## APPLICATION FOR CERTIFICATE OF APPROPRIATENESS HISTORIC CONSERVATION BOARD PUBLIC HEARING STAFF REPORT

APPLICATION #: COA20200021  
APPLICANT: Jose Garcia Design  
OWNER: Stuffed Realty LLC  
ADDRESS: **1208 Central Parkway**  
PARCELS: 081-0003-0124  
ZONING: CC-A  
OVERLAYS: Over the Rhine Historic District  
COMMUNITY: Over the Rhine  
REPORT DATE: April 15, 2020  
STAFF REVIEW: Beth Johnson, Urban Conservator

The request is for a Certificate of Appropriateness for a roof deck and roof access enclosure addition at the western portion of the building.

GEI ENGINEERING  
MASONRY REPAIR COMMENTS  
02-28-2020  
PAGE 3 OF 7

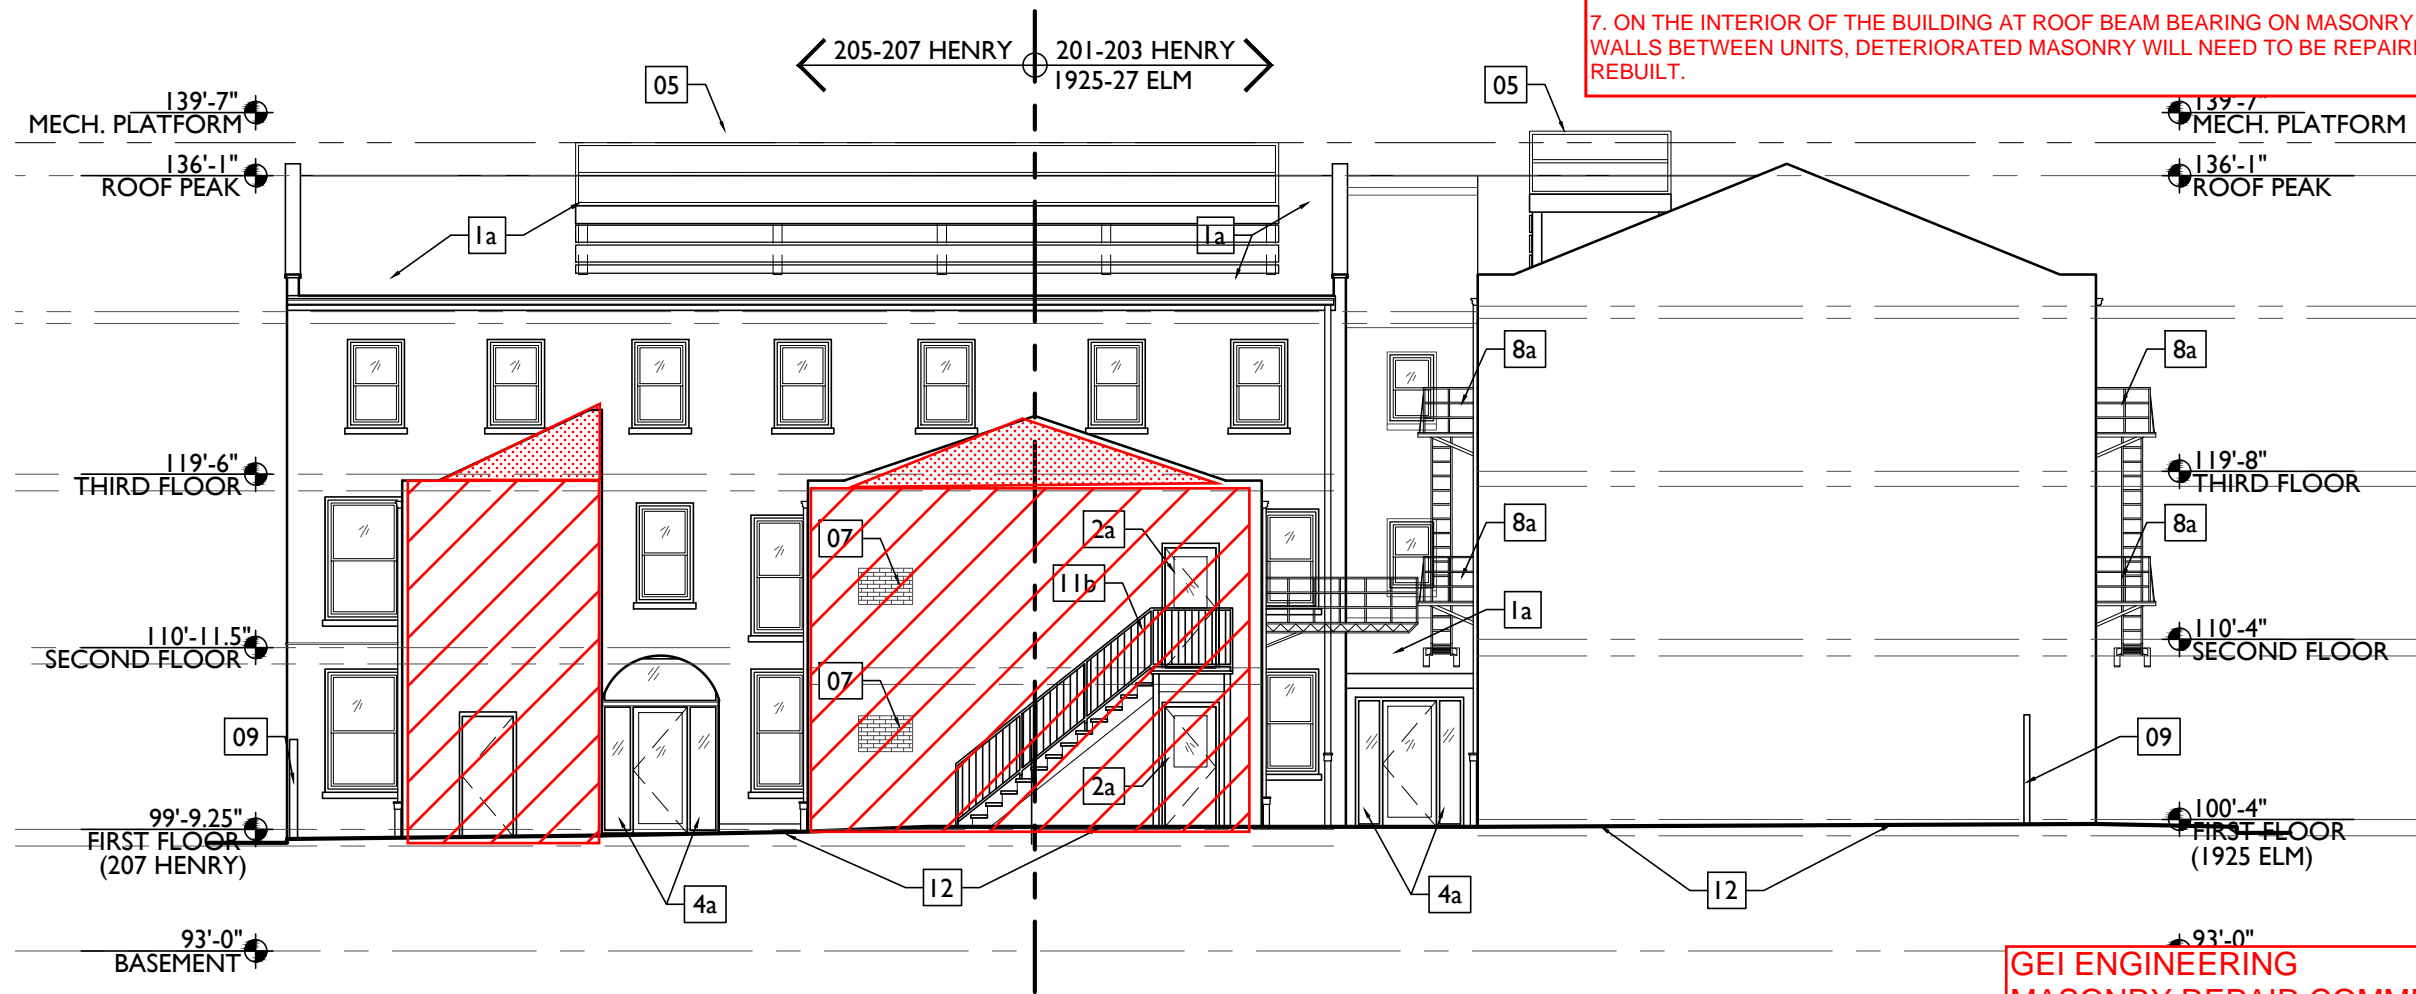
1. TUCKPOINT ALL MASONRY WALLS USING TYPE O MORTAR, TYPICAL ALL ELEVATIONS, UNO. REPLACE ALL MISSING, CRACKED, OR BROKEN BRICK.
2. CROSS HATCHED AREAS AT THE TWO STORY ADDITIONS IN THE COURTYARD REQUIRE SIGNIFICANTLY MORE REPAIRS THAN THE TYPICAL

3. SHADED AREAS SHALL BE REMOVED AND REBUILT WITH REINFORCED 8" CMU + SALVAGED BRICK EXTERIOR VENEER. REINFORCE CMU WITH #5 BARS AT 32"oc IN GROUTED CELLS. TOOTH IN NEW MASONRY TO EXISTING MASONRY.

4. REMOVE UP TO 2 COURSES OF EXISTING STONE FOUNDATION WALL AND INSTALL NEW CAST IN PLACE CONCRETE CAP w/ (3) #4 HORIZONTAL BARS TOP AND (2) #4 BENT BARS WITH 12" LONG HORIZONTAL LEG AND 18" (MIN) VERTICAL LEG, DRILL AND EPOXY INTO TOP OF EXISTING STONE WALL, 8: EMBED. SLOPE EXTERIOR GRADE OR DRIVE AWAY FROM WALL.

5. REPAIRS WITHIN PARGE COATED AREAS SHALL HAVE NEW PARGE COATING ADDED TO MATCH THE EXISTING PARGE COATING
6. NOTIFY ENGINEER IF POOR MASONRY CONDITIONS ARE FOUND DURING CONSTRUCTION.
